RE: Application under the *Canadian Environmental Assessment Act* (“CEAA”) for the Coal Valley Resources Inc. Robb Trend Project – Supplemental Information Request Responses - 2nd Round

**Robb Trend Project
Environmental Impact Assessment and Mine Permit Application
EPEA - 028-00011066; ERCB - 1725257**

**Supplemental Information Request Responses
Round 2**

Figure 39-1 Range in projected changes in global-mean temperature (°C), in response to a number of different emissions scenarios. From Barrow and Yu (2005).

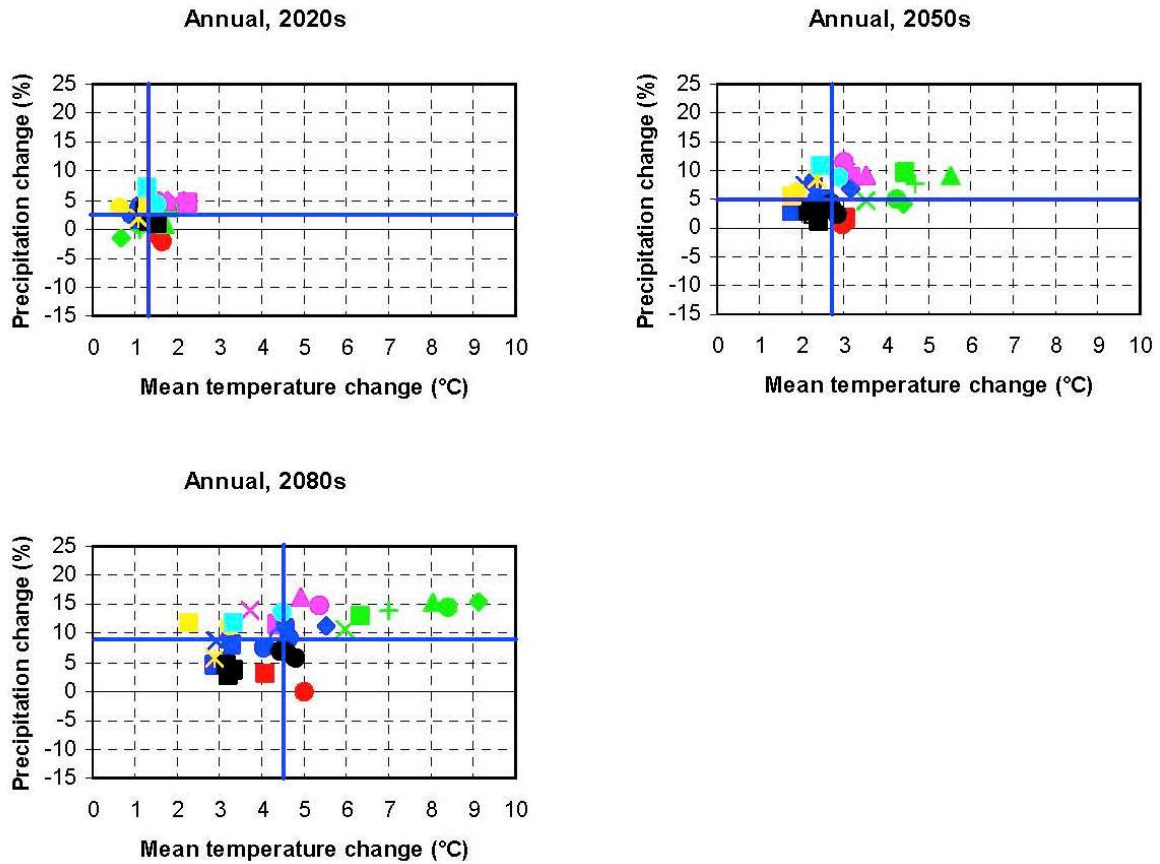
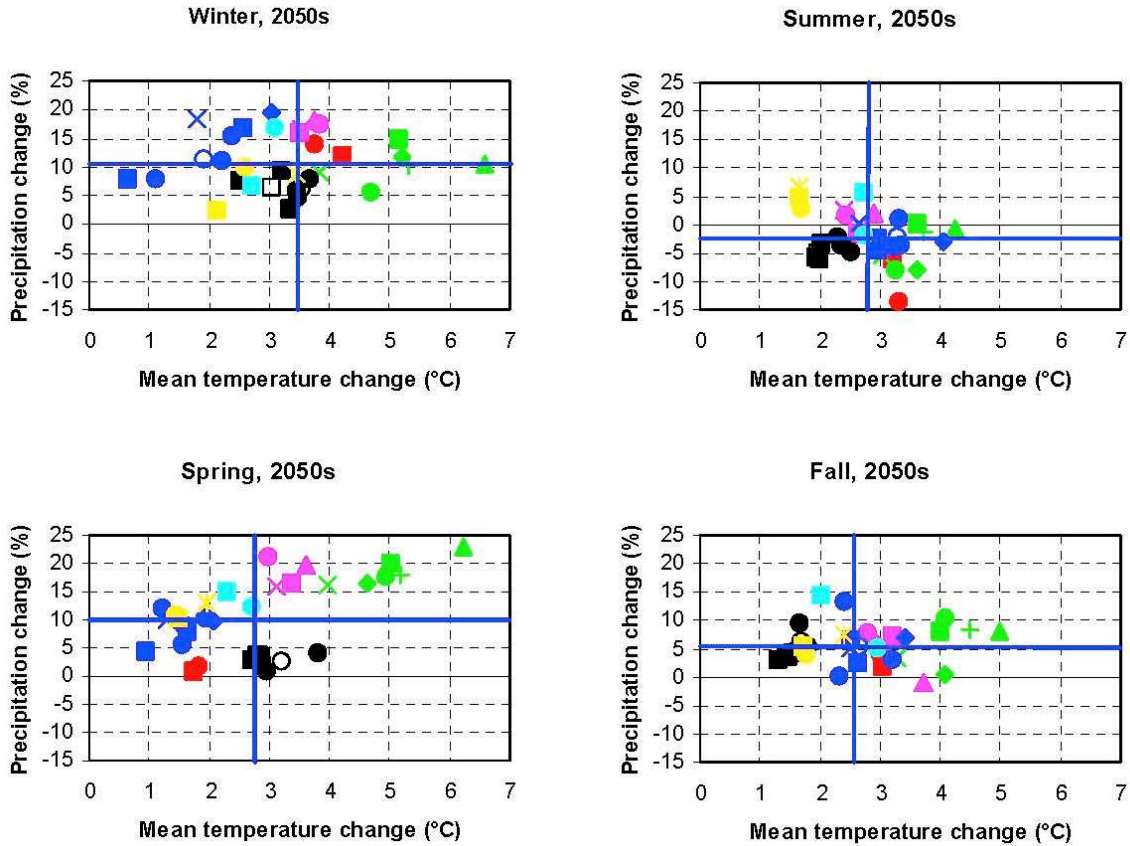
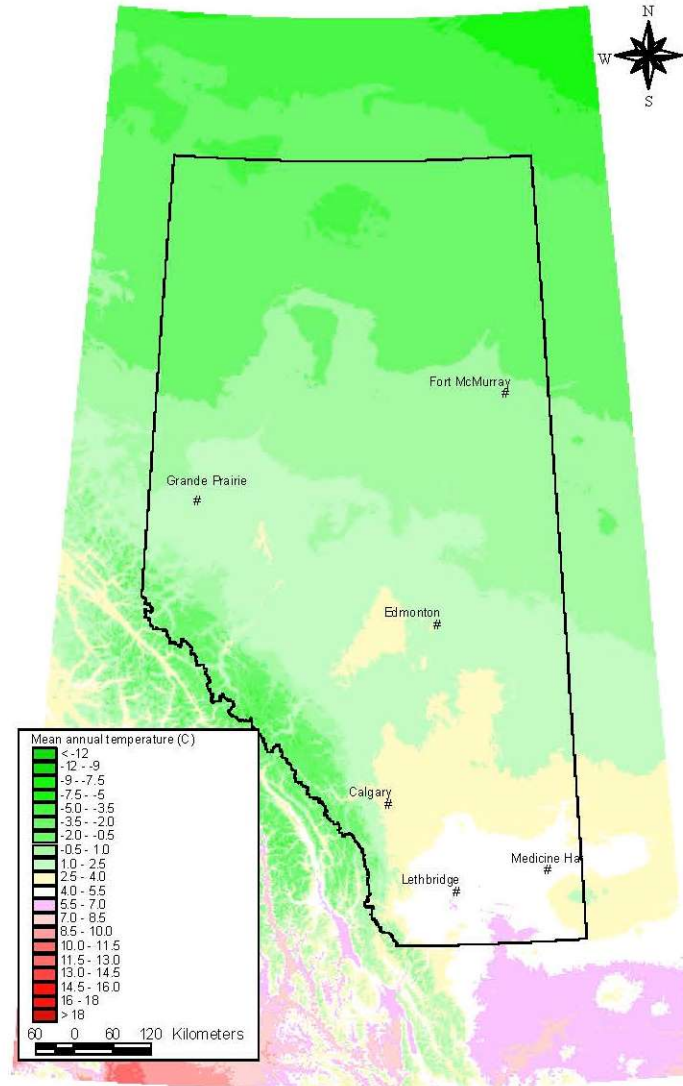
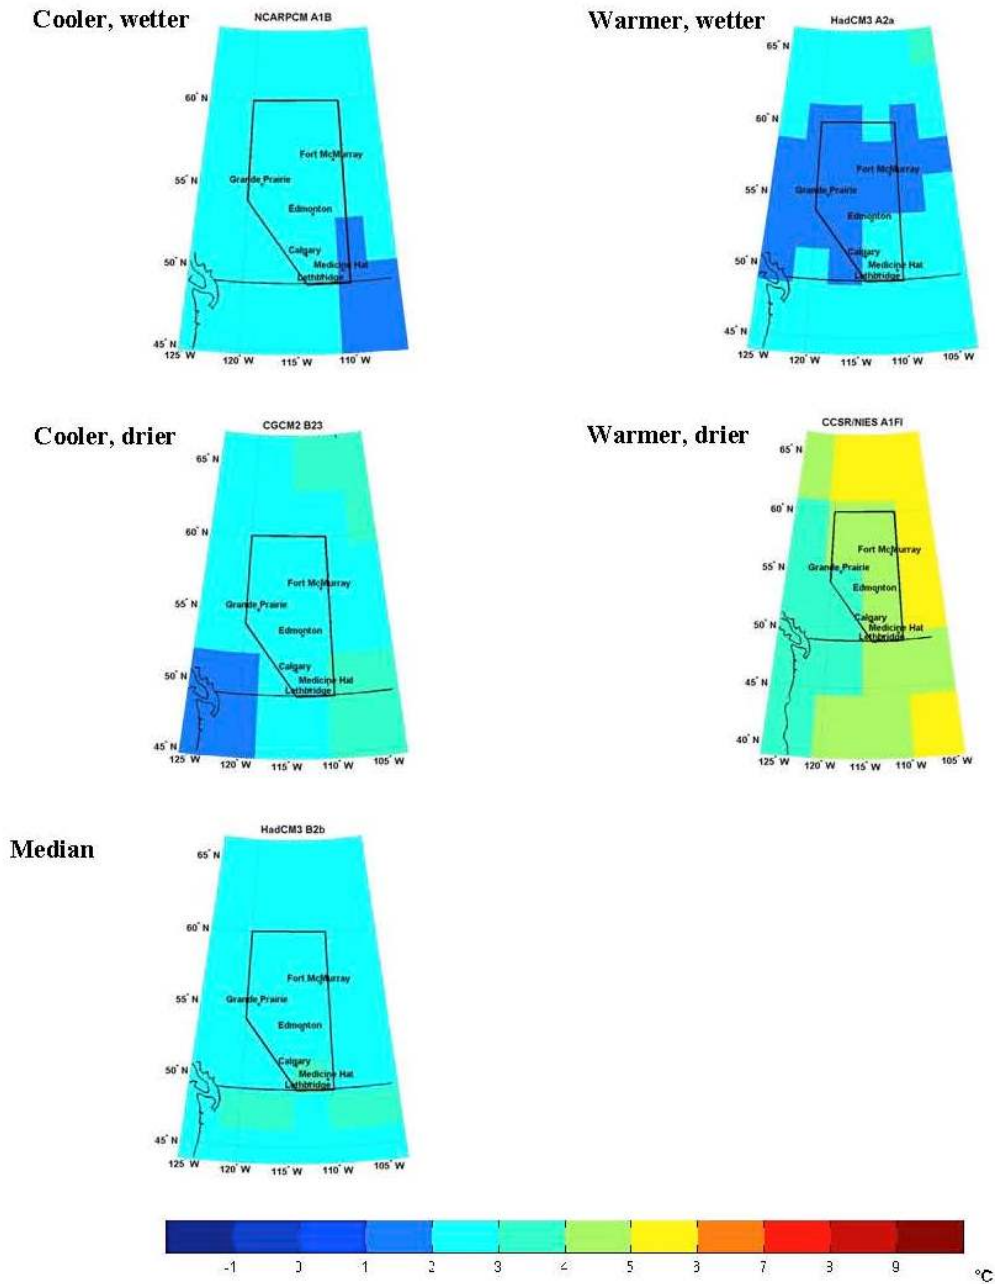
In their response to SIR 210, CVRI states that *climate change is indifferent to ecosystem makeup and that the minor spatial differences between Edmonton and Edson (CVM) are insignificant to climate change over the long term.*

- a) Provide a justification and rationale for the applicability of the predictions generated by using the Edmonton data (e.g. explain how model results are representative of the Edson (CVM) area when existing differences between Edmonton and Edson make Edmonton a poor surrogate for Edson). Response should reference model prediction uncertainty.

Barrow and Yu (2005) provided regional predictions for climate change in Alberta. From the many predictions available, five scenarios were selected to represent conditions which were cooler and wetter (NCARPCM A1B), cooler and drier (CGCM2 B2(3)), warmer and wetter (HadCM3 A2(a)) and warmer and drier (CCSRNIES A1FI) than median conditions (HadCM3 B2(b)). Climate change scenarios were constructed for minimum, mean and maximum temperature, precipitation, degree days > 5°C and annual moisture index.

Changes in annual mean temperature by the 2050s were predicted to be typically between 3°C and 5°C. Changes in maximum and minimum temperature are similar to those for mean temperature, although the changes in minimum temperature tend to be slightly greater than those for maximum temperature thus implying a general decrease in the diurnal temperature range. For the 2050s, changes in annual precipitation are generally within the range -10% to +15%, and any decreases in annual precipitation are generally driven by decreases in summer precipitation. By the 2080s, however, all five climate change scenarios indicate increases in annual precipitation of up to 15% in general. Degree days > 5°C and annual moisture index scenarios indicate increases of between 30-50% and 20-30% by the 2050s, respectively. The projected increases in annual moisture index are generally driven by the large increases in degree days above 5°C, rather than by decreases in precipitation.

Variability in model predictions for mean temperature are shown in Figure 39-1 over the three time ranges considered in the global circulation models, and in joint seasonal temperature and precipitation in Figure 39-2 for the time slice of the 2050s. Considering just the range in temperature in the 2050s in Figure 39-2, the range varies from about 2°C to 6°C depending on

Figure 39-4 shows the predicted change in climate over Alberta for the five scenarios examined. It shows that the change in climate is similar in most areas of the province for most scenarios and in particular for the median scenario used in the assessment. Changes in precipitation are more geographically variable but the change in precipitation is similar in the Edmonton and Edson areas.

Further, by considering the actual conditions in the period 1960-1990, Barrow and Yu described detailed climate scenario results for only six representative sites in Alberta – Lethbridge, Medicine Hat, Calgary, Edmonton, Grande Prairie and Fort McMurray. Edmonton is the closest of these cities to Edson and based on the discussion above, its climate change statistics were used to represent the Edson area.
